Service Bulletin

For Engines On Experimental Aircraft

Title: **AEL18839 Camshaft Marking for O/IO-375 Series Engines**

SB No.: **13-1**

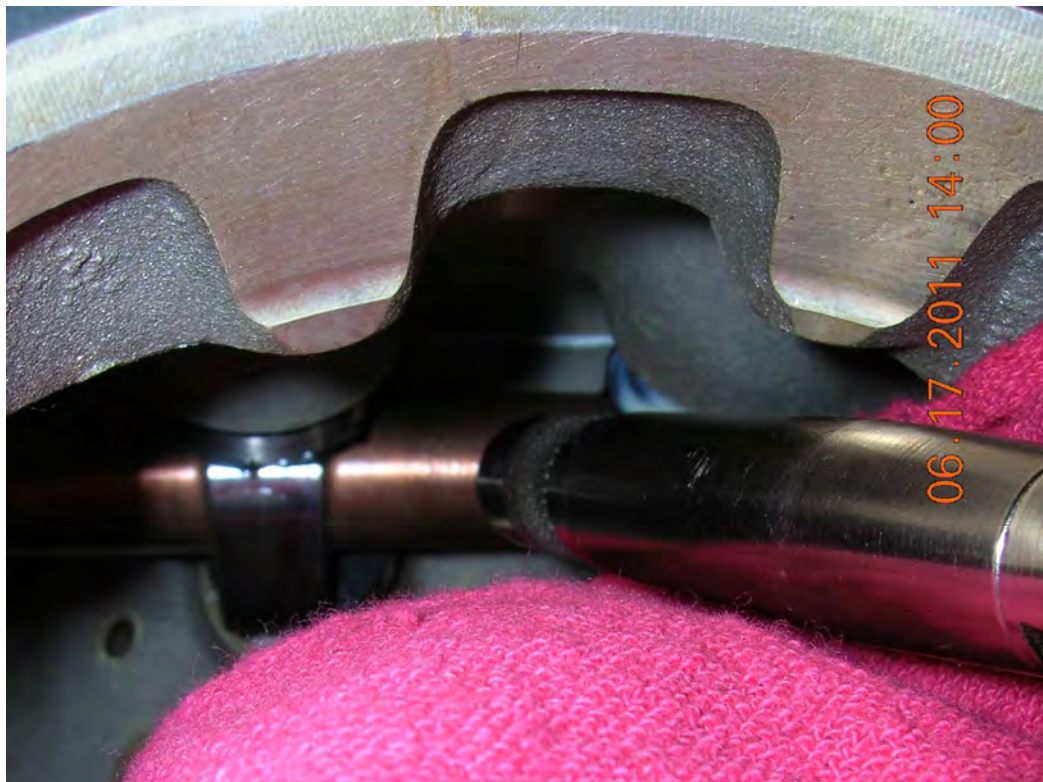
Remove cylinder #1 and associated piston and pin from the engine. See the photo below.

Rotate the camshaft to a position where the marking is accessible. See photo below.

Place a rag under the camshaft to catch any metal debris. Using a hand vibropeen or equivalent tool, obliterate the “FAA-PMA” marking. See the photos below.

Visually inspect the marking to ensure the FAA-PMA is completely obliterated, photograph the obliterated marking with legible serial number and return to service.
